Contract #: 04-0120F4Cty: SF/ALA Rte: 80 PM: 13.2/13.9File #: 69.25B**QUALITY ASSURANCE -- NON-CONFORMANCE REPORT****Location:** Changxing Island, Shanghai, P.R. China**Report No:** NCR-000854**Prime Contractor:** American Bridge/Fluor Enterprises, a JV**Date:** 03-Oct-2010**Submitting Contractor:** Zhenhua Port Machinery Company, Ltd (ZPMC), Changxing Island**NCR #:** ZPMC-0816**Type of problem:****Welding****Concrete****Other****Welding****Curing****Procedural****Bridge No:** 34-0006**Joint fit-up****Coating****Other****Component:** Longitudinal Diaphragm in Segment 10CW**Procedural****Procedural****Description:**

**Reference Description:** Flame cutting performed without Engineer's approval and utilizing mechanical guide on LD (Segment 10CW)

**Job Name:** SAS Superstructure  
**Document No:** 05.03.06-000811

**Reference Description:** Flame cutting performed without Engineer's approval and utilizing mechanical guide on LD (Segment 10CW)

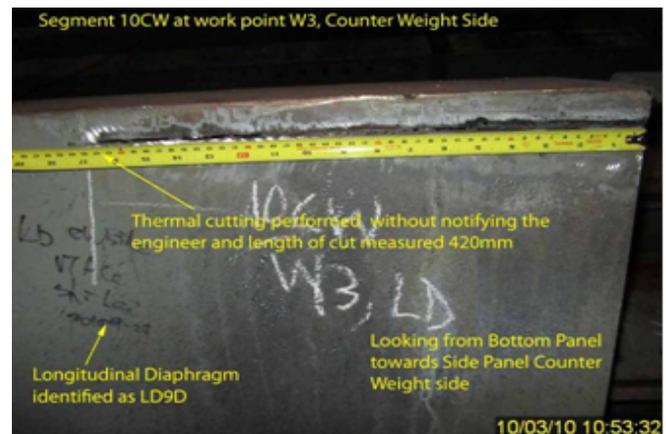
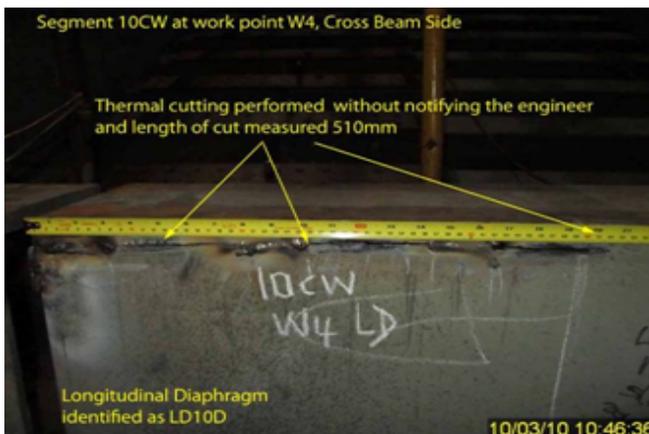
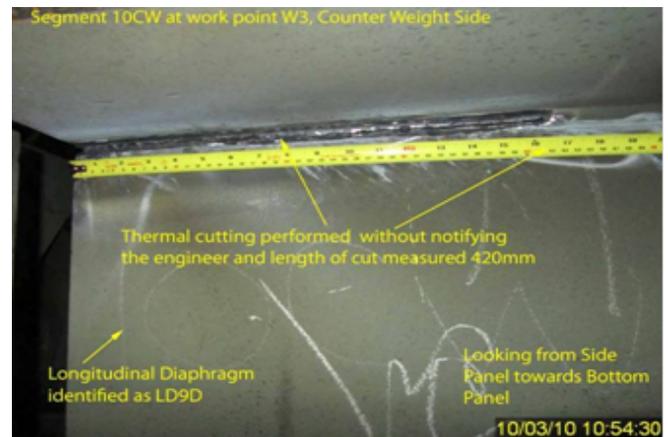
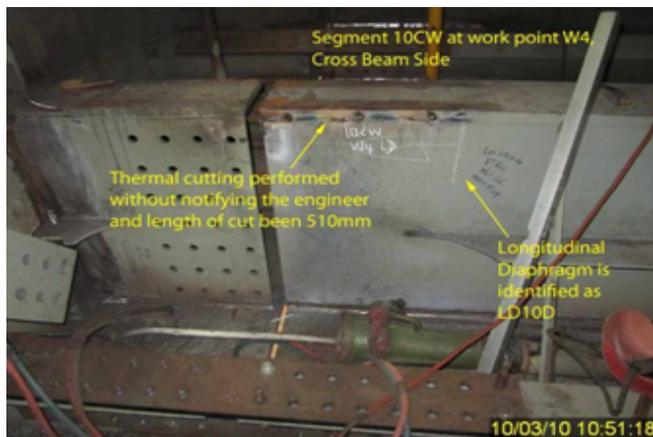
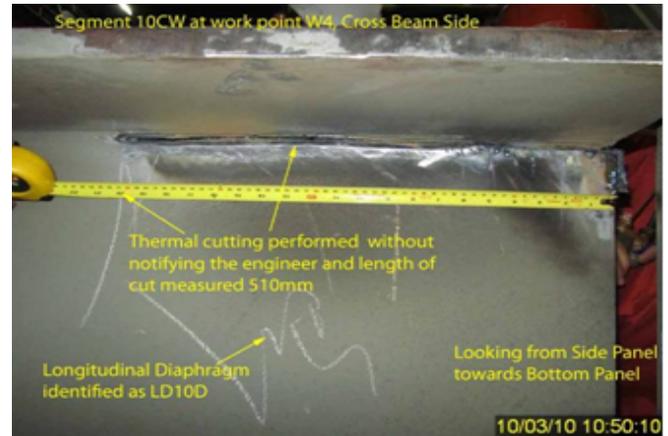
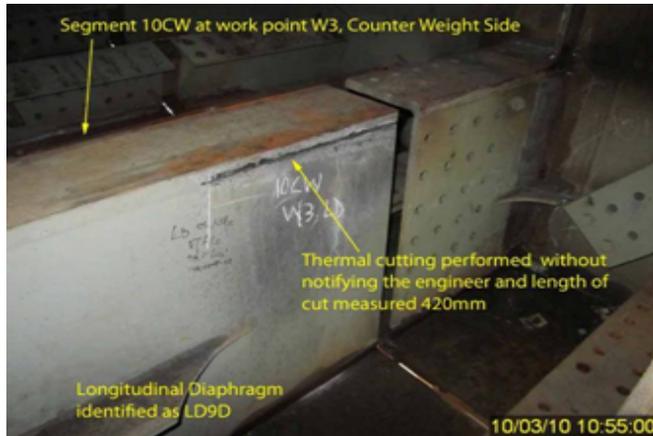
During Caltrans Quality Assurance (QA) random in process observations of the trial assembly of OBG segments 10CW, this QA Inspector discovered the following issues:

- ZPMC workers have removed a weld joint connecting Longitudinal Diaphragm (LD) web to flange side with an approximate length of 510mm at LD located at work point W4 and 420mm at LD located at work point W3.
- The Contractor failed to notify the Engineer of the intent to remove/cut the above welds.
- The removal of the welds was performed by free-hand flame cutting while it is possible to perform mechanically guided flame cutting.
- These free hand flame cutting performed were not in the scope of "Submittal 872R1: Free Hand Flame Cutting Procedure," as the cuts were over 300mm and that mechanical guides are available.
- These welds are Complete Joint Penetration (CJP), joining Longitudinal Diaphragm Web to Flange: Longitudinal Diaphragm at work point W3 identified as LD9D; Longitudinal Diaphragm at work point W4 identified as LD10D.

-AWS D1.5 (02) Section 3.7.5: The Engineer shall be notified before improperly fitted and welded members are cut apart.

-Special Provisions Section 8-3: The Engineer shall be notified in writing when welding problems, deficiencies, base metal repairs, or any other type of repairs not submitted in the WQCP are discovered and also of the proposed repair procedures to correct them.

-Submittal 872R1: Free Hand Flame Cutting Procedure: "Request Engineer's approval for flame cutting when mechanically guided flame cutting is not practical due to accessibility, cross sectional geometry and or position."  
"

Propose a resolution for the identified non-conformance with revised procedures to prevent future occurrences. A response for the resolution of this issue is expected within 7 days.

The repair work was performed per the WRR along with acceptable NDT documentation. The proposed resolution is acceptable. This NCR is considered closed.

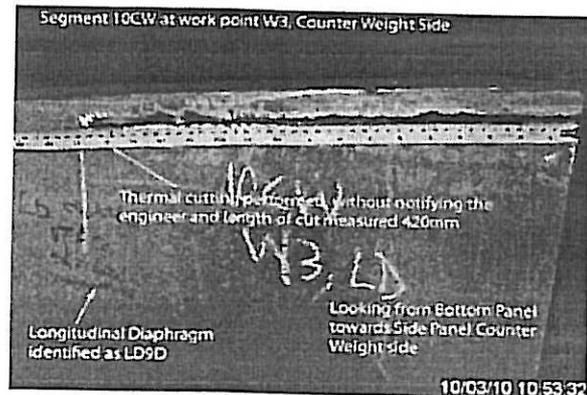
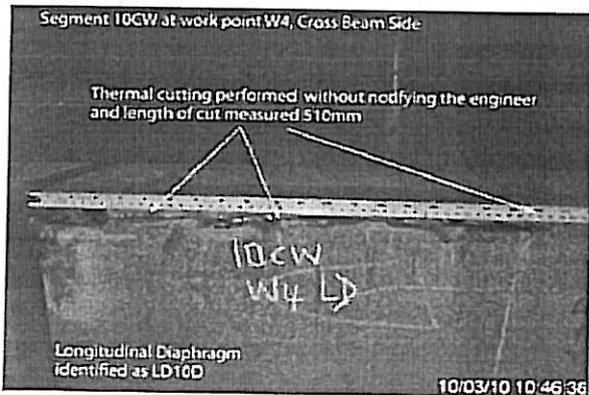
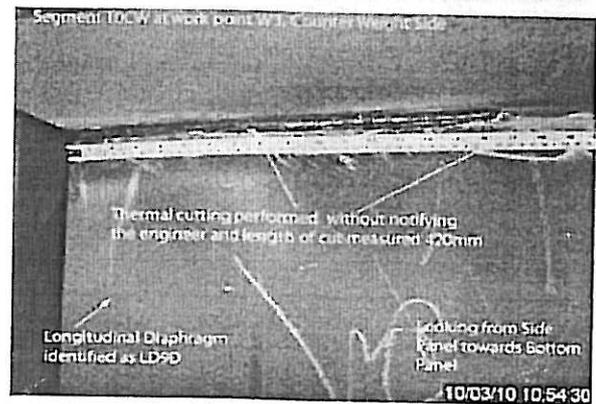
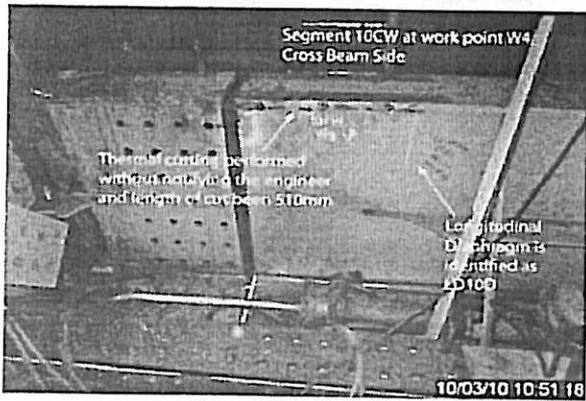
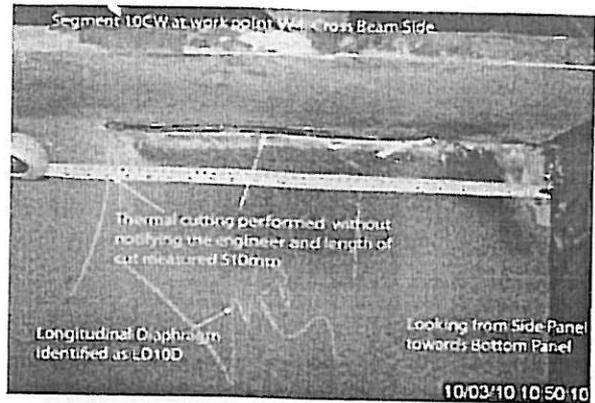
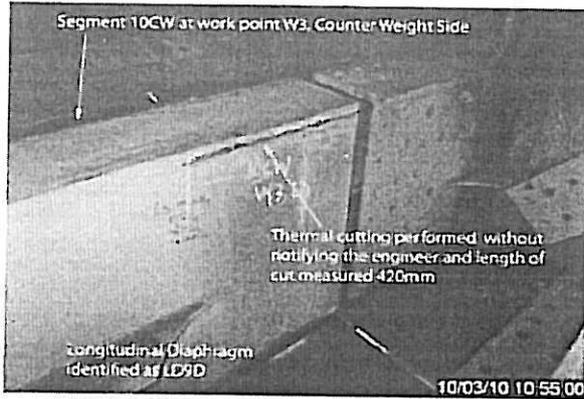
During Caltrans Quality Assurance (QA) random in process observations of the trial assembly of OBG segments 10CW, this QA Inspector discovered the following issues:

- ZPMC workers have removed a weld joint connecting Longitudinal Diaphragm (LD) web to flange side with an approximate length of 510mm at LD located at work point W4 and 420mm at LD located at work point W3.
- The Contractor failed to notify the Engineer of the intent to remove/cut the above welds.
- The removal of the welds was performed by free-hand flame cutting while it is possible to perform mechanically guided flame cutting.
- These free hand flame cutting performed were not in the scope of "Submittal 872R1: Free Hand Flame Cutting Procedure," as the cuts were over 300mm and that mechanical guides are available.
- These welds are Complete Joint Penetration (CJP), Joining Longitudinal Diaphragm Web to Flange: Longitudinal Diaphragm at work point W3 identified as LD9D; Longitudinal Diaphragm at work point W4 identified as LD10D.

-AWS D1.5 (02) Section 3.7.5: The Engineer shall be notified before improperly fitted and welded members are cut apart.

-Special Provisions Section 8-3: The Engineer shall be notified in writing when welding problems, deficiencies, base metal repairs, or any other type of repairs not submitted in the WQCP are discovered and also of the proposed repair procedures to correct them.

-Submittal 872R1: Free Hand Flame Cutting Procedure: "Request Engineer's approval for flame cutting when mechanically guided flame cutting is not practical due to accessibility, cross sectional geometry and or position."

Contractor will perform repair work per the Welding Repair Report. NDT will be performed after repair. Contractor will discuss and review the free hand cutting procedure with the production team to prevent future occurrence. Contractor will provide refresher training to reduce the possibility of repeat of the non-conformance.

Contractor repaired the work per WRR provided. NDT performed after repair. NDT documentation showed the repair is acceptable. Contractor conducted refresher training to reduce to personnel involved to ensure similar non-conformance will not be repeated in future.

Draft of Welding Discontinuity:

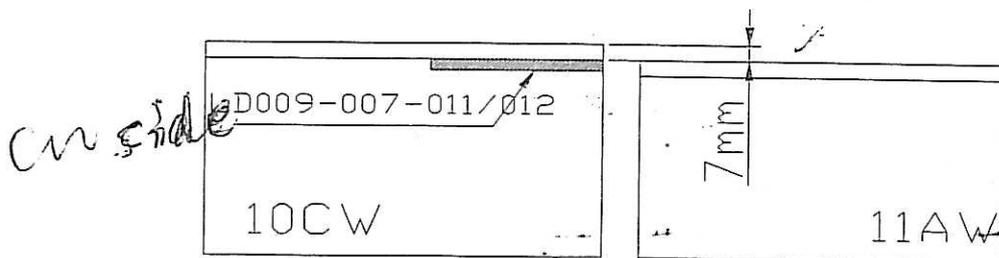
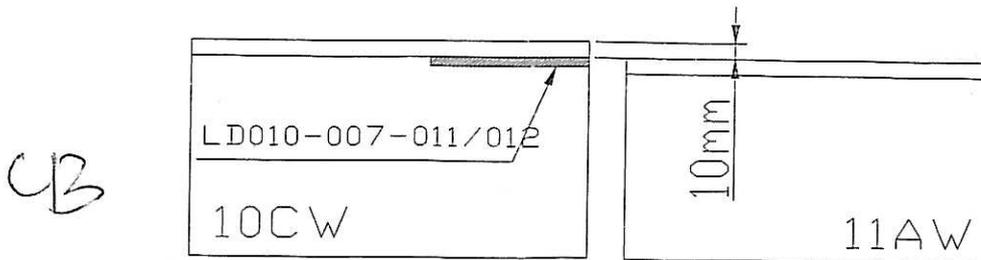
After inspection 10CW and 11AW, the misalignment was 7mm at longitudinal diaphragm non face cross beam, 10mm at longitudinal diaphragm face cross beam, and needed to remove welds at longitudinal diaphragm skin plate and edge plate, welds ID: LD009-007-011/012; LD010-007-011/012. the detail sees the following draft.

Remark: cut weld on shadow.

Weld distortion and fabricate error.

- 1.Remove the weld on shadow by gouging or heat cutting.
- 2.Adjust the misalignment and the straightness to meet the tolerance by outer force.
3. Prepare right excavation according to the approved WPS.
4. Perform 100% VT and MT inspection to the groove to ensure no defects exist prior to welding;
5. Preheat and weld according to approved WPS.
- 6: Grind the welds with a smooth surface.
7. Perform NDT inspection to the repair area according to work drawing.
